MEETING AGENDA
SESSION OF THE PLANNING ADVISORY BOARD
CITY OF KISSIMMEE
CITY HALL, COMMISSION CHAMBERS
101 CHURCH STREET, KISSIMMEE, FLORIDA 34741-5054
WEDNESDAY, DECEMBER 20, 2023 AT 6:00 PM

Public Hearing - Conditional Use with Site Plan Waiver for a private school at 3030 & 3051 Lions Ct. - Nazaret Christian Academy - CU-23-0012

ANSWER TO COMMENTS FROM: PLANNING - Brenda Ryan

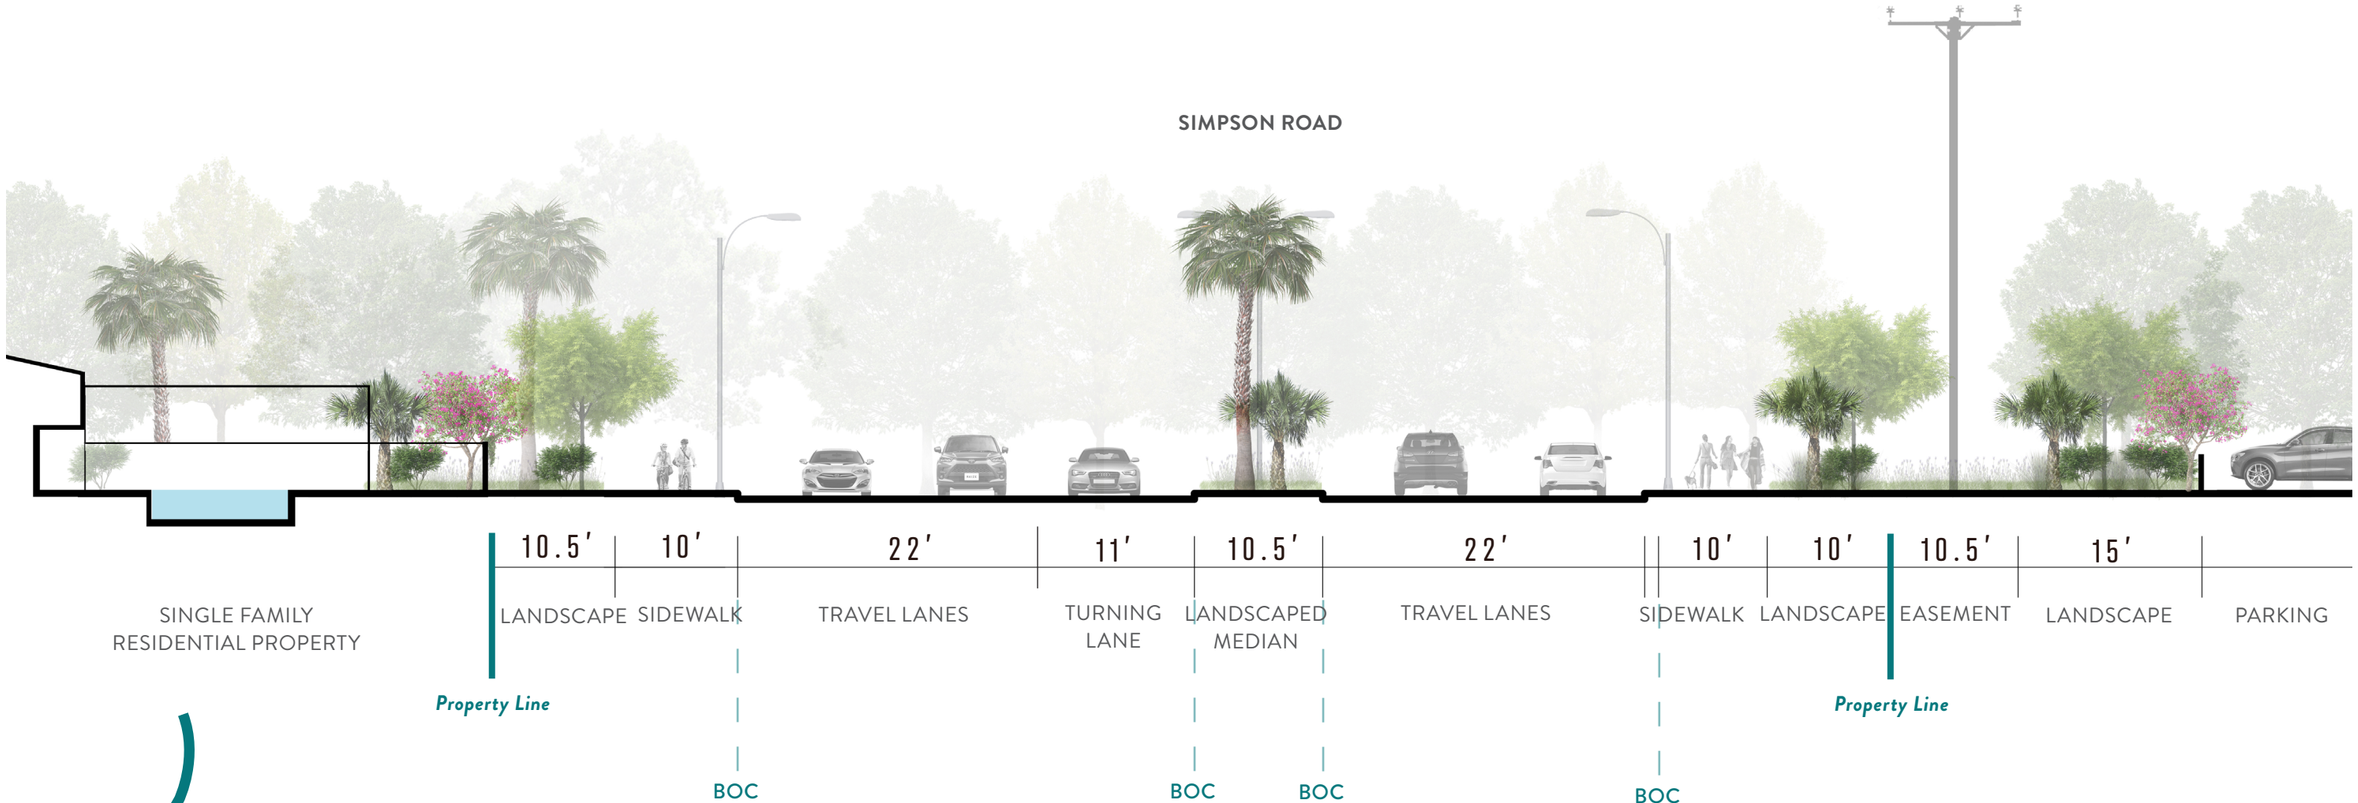
Page 10: Figure 2 – Build to line or setback?
